SUPPLEMENTAL SHEET

CONTRACT CHANGE ORDER NO. _____
SHEET ___ OF ___

SAN FRANCISCO OAKLAND BAY BRIDGE
EAST SPAN SEISMIC SAFETY PROJECT
SELF-ANCHORED SUSPENSION BRIDGE
(SUPERSTRUCTURE & TOWER)

TOWER SPLICE DETAILS NO. 23

OPTION A - WELD SKIN PLATE FROM BOTH SIDES

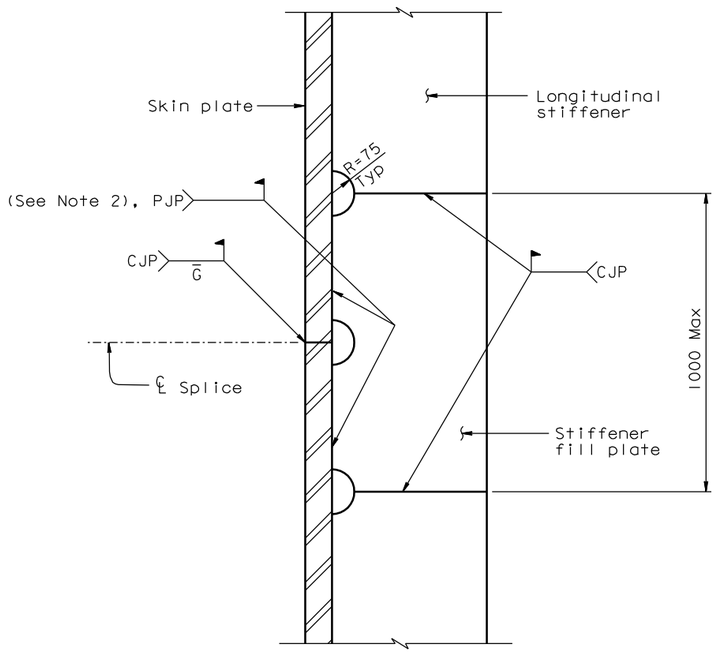
(For all splice elevations)

OPTION B - WELD SKIN PLATE FROM OUTSIDE ONLY

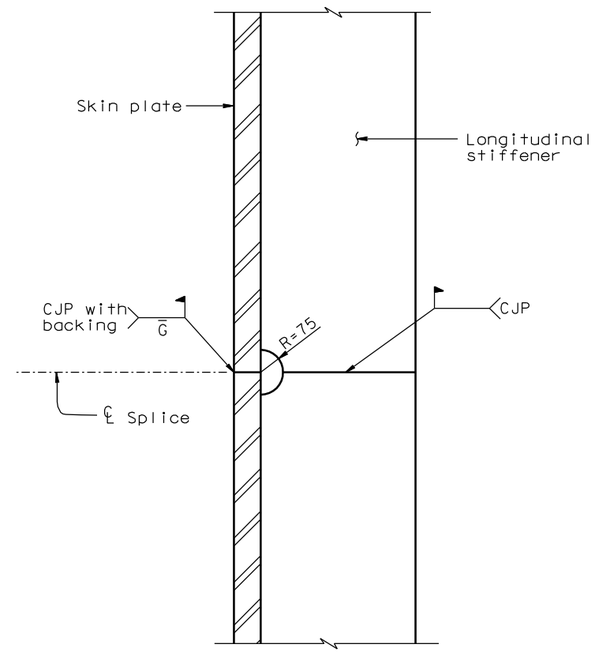
(For all splice elevations)
